Product Change Notification

Change Notification #: 116896 - 02
Change Title: Humidity Indicator Card (HIC),
PCN 116896-02, Transport Media,
Adding Additional Desiccant Pouch for **Half
stack and Full stack** Tray and **13” & 14”**
Tape & Reel Packed Products & Relocating
HIC placement
**Reason for Revision: Providing additional
clarification on the change**

Date of Publication: June 17, 2019

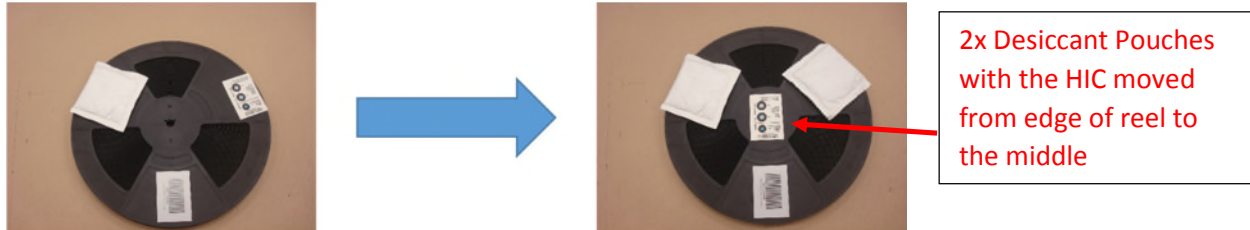
In order to address the marginality of coloration displayed on the Humidity Indicator Card (HIC) of desiccant packed products, Intel will be adding an additional desiccant pouch. The additional desiccant pouch is for Ball Grid Array (BGA) applying to Tray packed product that are shipped in either a Half-Height Intermediate Box (ie Half Stack) or a Full Intermediate Box (ie Full Stack) as well as **13” and 14”** Tape & Reel packed products. Intel Small I-box pack, Tube Pack and 7” Tape & Reel pack are not included in this change and will remain at one desiccant pouch.

As a result of adding the new desiccant pouch, the placement of the HIC will be moved to a new location. For Tray stacks, the **HIC** will be placed in the middle, while for **13” and 14”** Tape & Reels the HIC will placed in the middle of the Reel. (Pictures below are for example only)
